**SUBJECT: NEW VEHICLE DEMONSTRATION / DELIVERY HOLD – *Supplement #1***  
**Safety Recall 20S73**

Certain 2021 Model Year Econoline Equipped with 7.3L Engine  
 Engine Cover Thermal Management

## CERTAIN 2021 MODEL YEAR ECONOLINE VEHICLES EQUIPPED WITH A 7.3L ENGINE — ENGINE COVER THERMAL MANAGEMENT

**FIGURE 2**

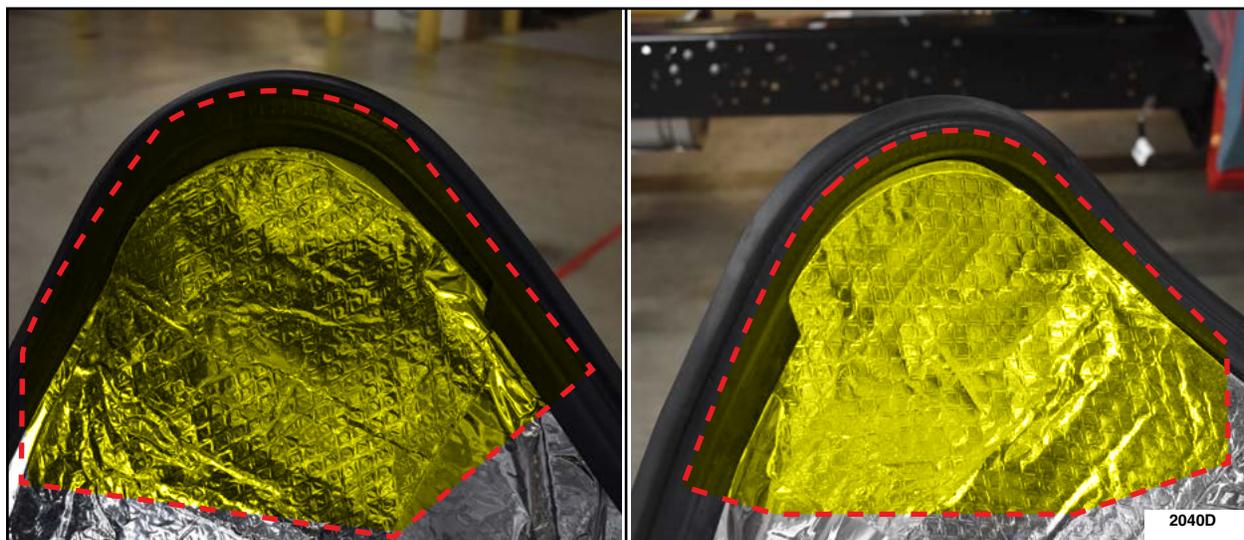
4. Are there any gaps present between the thermal shield and the engine covers weatherstrip on either side of the engine cover as shown in Figure 2?

YES - Proceed to the Thermal Patch Kit Installation Procedure.  
NO - No further action is required.
